# **THE 2000 FIRST ROBOTICS COMPETITION**

## **TEAM UPDATE #1**

Date: January 11, 2000

## CORRECTIONS AND UPDATES TO THE MANUAL

Figure 1.1: Playing Field Layout

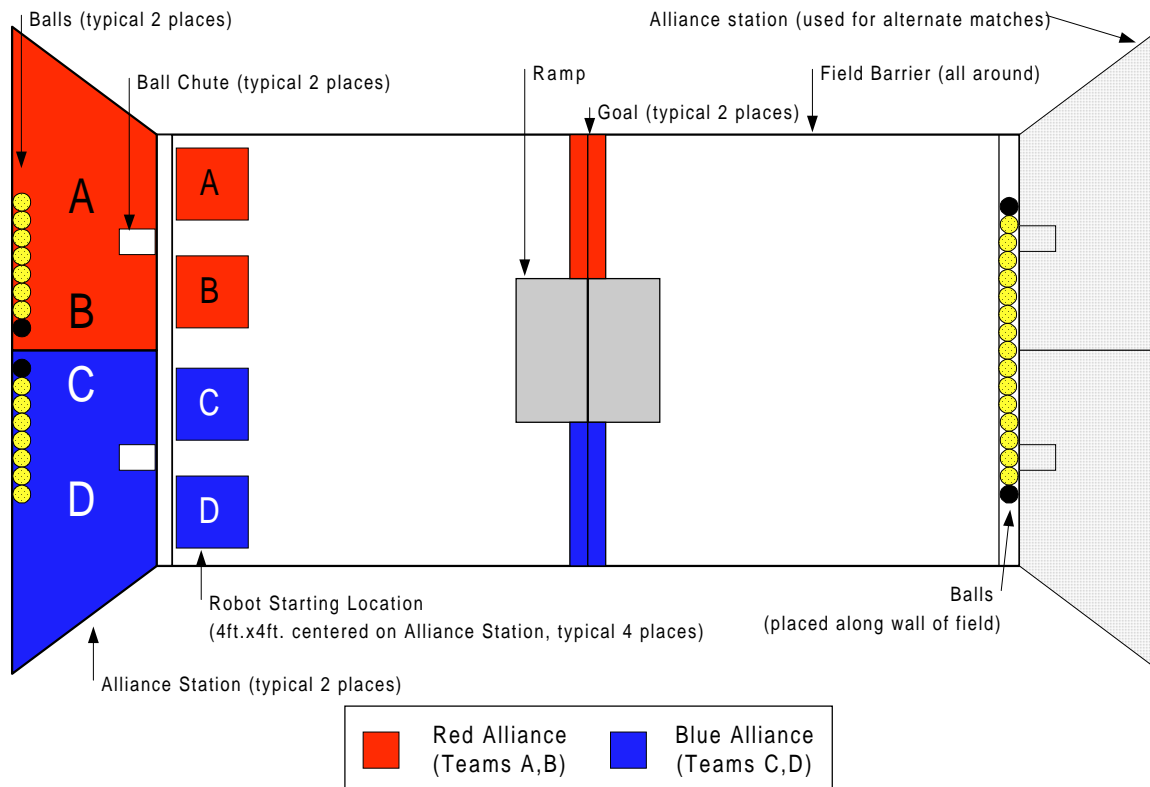
Figure 1.1 in The Game section contained a mistake regarding the number of balls in the Alliance Stations. Below is an updated Figure 1.1:
